ROADWAY DESIGN BULLETIN 16-04

SUBJECT: Single-Slope Concrete Barriers

This bulletin supplements **Roadway Design Bulletin** 16-02 MASH-16 Implementation Plan.

38" SHOULDER BARRIER

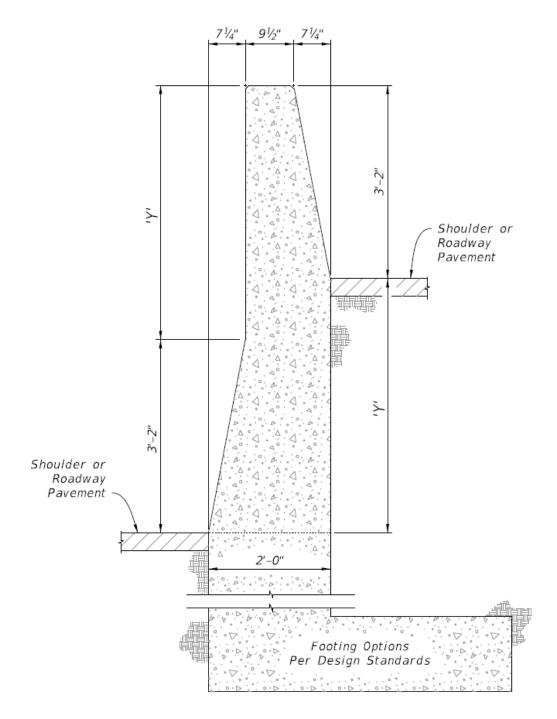
Use the Single-Slope Concrete Barriers shown in Attachment 'A' in lieu of the F-Shape Concrete Barriers shown in the current *Design Standards*, Indexes 410 and 411.

A redeveloped version of *Design Standards* Indexes 410 and 411 will be released with the *FY 2018-19 Design Standards eBook*, where the Single-Slope Concrete Barrier shapes shown in Attachment 'A' will replace F-Shape Concrete Barriers, and all reinforcing details, foundation details, and other miscellaneous details will be included to continue the similar functionality of the current Indexes. The 38", 44", and 56" inch height Single-Slope Barriers shown in Attachment 'A' will replace the 32", 42", and 54" height F-Shape Barriers, respectively.
